# UNITED STATES PATENT AND TRADEMARK OFFICE

APPLICATION NO.	FILING DATE	FIRST NAMED INVENTOR	ATTORNEY DOCKET NO.	CONFIRMATION NO.
10/820,636	04/08/2004	Sridhar Ranganathan	17,872	8821

<b>Office Action Summary</b>	<b>Application No.</b> 10/820,636	<b>Applicant(s)</b> RANGANATHAN ET AL.	
	<b>Examiner</b> Keshia Gibson	<b>Art Unit</b> 3761

## **DETAILED ACTION**

Fig. A: Examiner's markup of Gertzman's Fig. 2 to identify subtended angle.

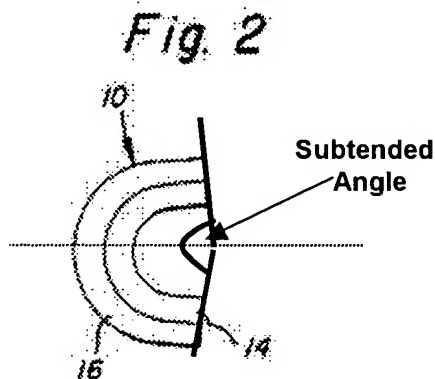
In regard to Claims 7, in Fig. A below, the structure 10 of Gertzman et al. is marked up based on examiner's understanding of "subtended angle." As can be seen in Fig. A, the absorbent structure 10, has a subtended angle of about 180 degree or less.

Furthermore, this property is considered to be inherent based on the same structure/same property as provided in the discussion of Claim 1.
